Model: Model PG-C1		Date: 14-Jun-06	No.: MB229001
Modified Article: Parts catalog correction: Engine Unit		Prepared by: A. Ishiyama	
From: 1st Technical Support Sec. Service Support Dept.			
Reason for Modification:	<input checked="" type="checkbox"/> Parts catalog correction <input type="checkbox"/> To facilitate assembly <input type="checkbox"/> Part standardization	<input type="checkbox"/> Vendor change <input type="checkbox"/> To improve reliability <input type="checkbox"/> Other	<input type="checkbox"/> To meet standards ()
Modification Schedule:	From first mass production.

Model: Model PG-C1		Date: 14-Jun-06	No.: MB229002
Modified Article: Parts catalog correction: Waste Ink Tank		Prepared by: A. Ishiyama	
From: 1st Technical Support Sec. Service Support Dept.			
Reason for Modification:	<input checked="" type="checkbox"/> Parts catalog correction <input type="checkbox"/> To facilitate assembly <input type="checkbox"/> Part standardization	<input type="checkbox"/> Vendor change <input type="checkbox"/> To improve reliability <input type="checkbox"/> Other	<input type="checkbox"/> To meet standards ()
Modification Schedule:	From first mass production.

Part Change Information

3. OPERATION PANEL (B229)

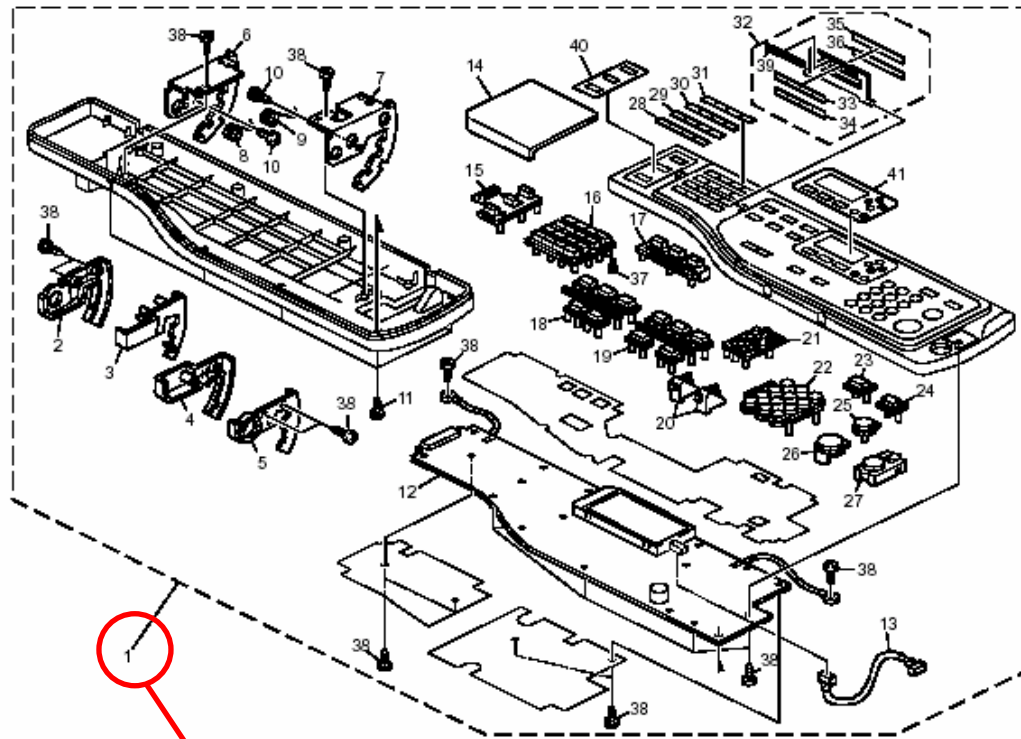
Change: The parts in the table were deleted.

Reason: As per a request from the operation panel vendor.

Important: If one of the deleted parts needs to be replaced, replace the operation panel unit (B2291433, B2291434, B2291435).

Only #1 is available

Page 3

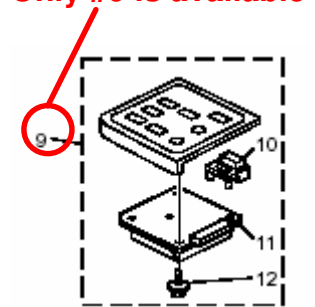
Change: The parts were deleted.

Reason: As per a request from the operation panel vendor.

Important: If one of the deleted parts needs to be replaced, replace the operation panel unit (B2291421, B2291422).

Only #9 is available

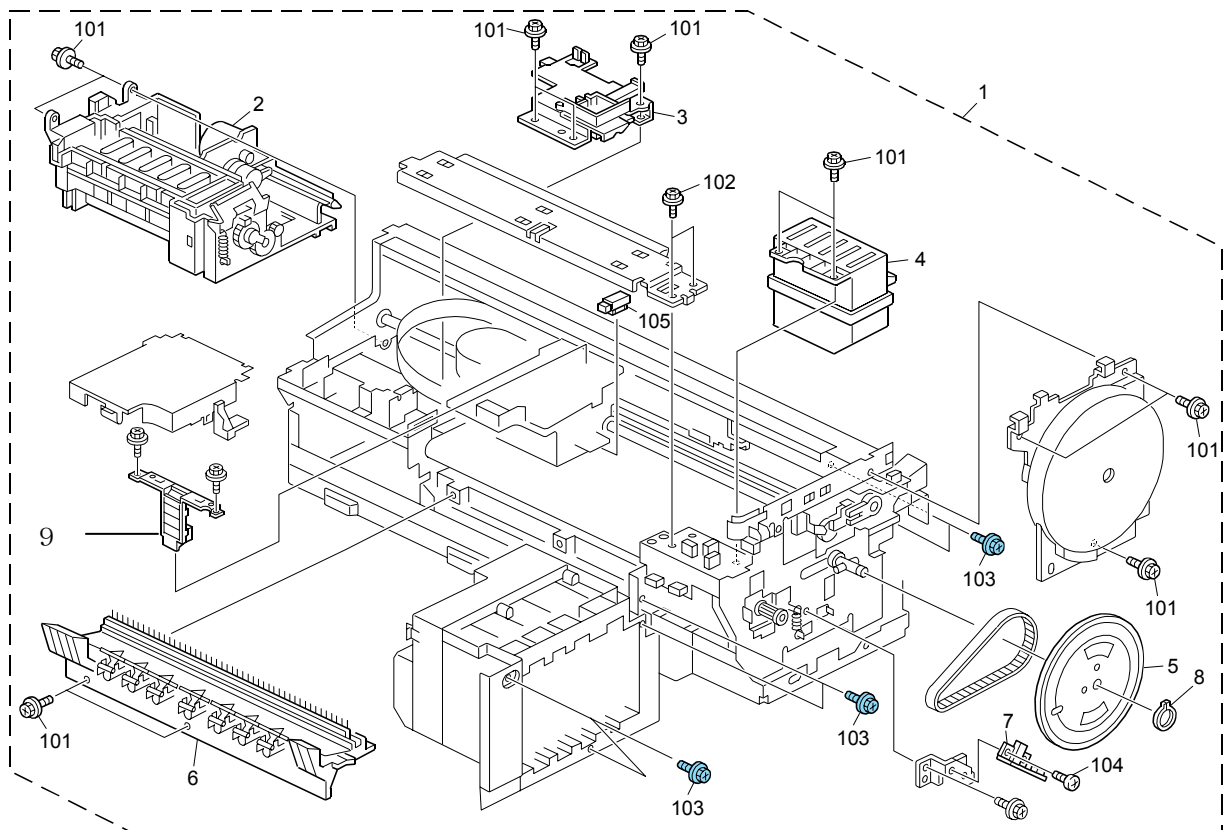
The illustration has added as shown below.

Old part number	New part number	Description	Q'ty	Int	Page	Index	Note
-	B2292426	Encoder Sensor	1		29	9

Change/Reason: Parts Catalog correction

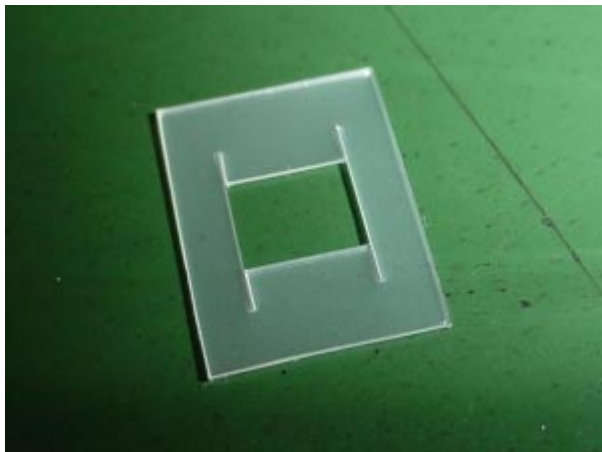
Change: Two Mylar sheets were added to the side fence racks.

Reason: To improve the mobility of the side fence.

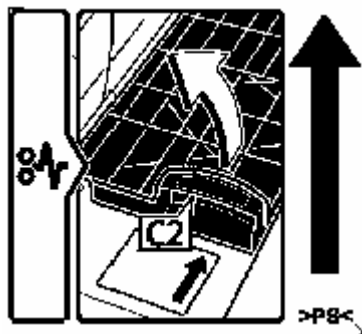
Change: The decal was added to the front inner cover.

Reason: To clarify the position of the C2 cover to the user.

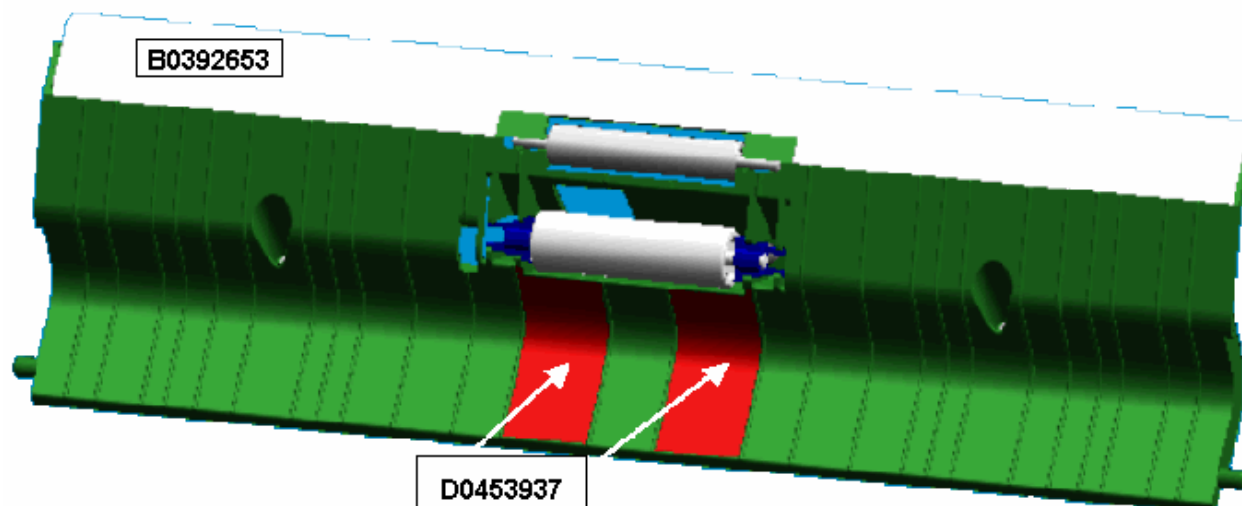
Change:

- 1) The shape of the Mylar was changed.
- 2) A new Mylar was added.

Reason: To further improve paper transport.

Important: When you replace any of these parts for the first time, make sure to install all the new parts **together as a set**.
